## Furrion cook top LP line

### Description

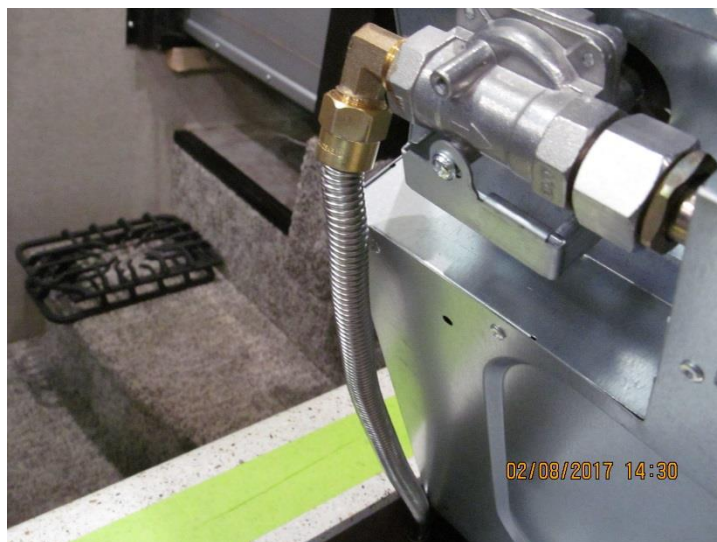
On certain Toy Hauler fifth wheel trailers manufactured with a Furrion cook top. The LP hose might be pushing against the oven causing stress on the LP hose connector at the cook top. This could result in a gas leak and could causing unsafe operation, which could lead to an increased risk of injury and/or damage to property.

6. Remove the LP hose, be sure to use a back-up wrench to hold valve to prevent damage.

7. Tighten the fitting on the end of the flexible gas connector.

8. Install one end of the flexible gas connector to the LP hose and the other to the cook top. Be sure to hold the valve with a back-up wrench to prevent damage.

9. Bend or flex the flexible gas connector so that it is against the bottom of the cook top.
